Access Compliance Report Public Rights-of-Way (Curb Ramps)

Main Street: VANDERLIP_PL Cross Street: HOLT_AVE Location: NW

ADA ID: RPRK220124115431 Ramp Type: Type 4 - Parallel Initial Pass/Fail: Fail Overall Compliance: No Severity Score: 30

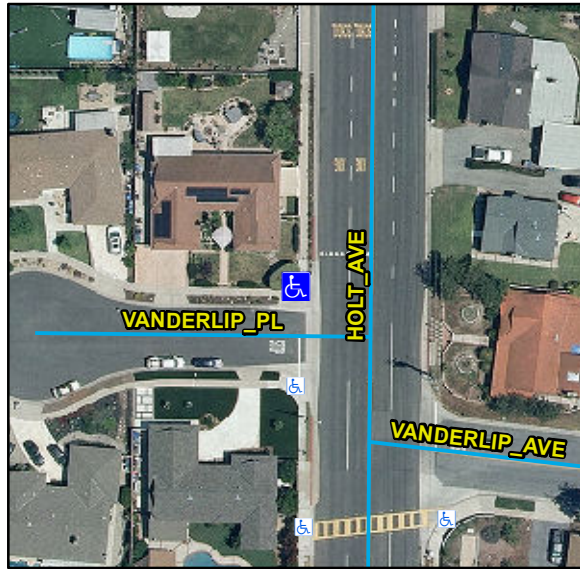
Compliance	Description	Data	Compliance	Description	Data
N/A	Ramp Length LT (in)	114	N/A	Ramp Length RT (in)	105
Yes	Ramp Width LT (in)	89	Yes	Ramp Width RT (in)	89
No	Ramp Run Slope LT (%)	8.6	Yes	Ramp Run Slope RT (%)	8
No	Ramp Cross Slope LT (%)	5.3	No	Ramp Cross Slope RT (%)	5.2
N/A	Landing Present	N/A	N/A	DWS Provided	N/A
N/A	Landing Length (in)	N/A	N/A	DWS Contrast	N/A
N/A	Landing Width (in)	N/A	N/A	DWS Length (in)	N/A
N/A	Landing Run Slope (%)	N/A	N/A	DWS Full Width	N/A
N/A	Landing Cross Slope (%)	N/A		DWS Offset Type	N/A
N/A	Landing Movement Obstructed?	N/A	N/A	DWS Offset Left (in)	N/A
	Landing Movement Type	N/A	N/A	DWS Offset Right (in)	N/A
N/A	Landing Shared	N/A			
N/A	Clear Space	Yes			
N/A	Clear Space To Crosswalk (in)	N/A			
N/A	Marked Crosswalk 1	No	N/A	Marked Crosswalk 2	No
	Crossing 1 Direction	S		Crossing 2 Direction	E
	Marked Crosswalk 1 Width (in)	N/A		Marked Crosswalk 2 Width (in)	N/A
N/A	Ramp Inside Crosswalk 1	N/A	N/A	Ramp Inside Crosswalk 2	N/A

Remove & Replace Curb Ramp With Two New Directional Ramps or Equivalent.

R304.3.2, R304.5.3, STD 1115
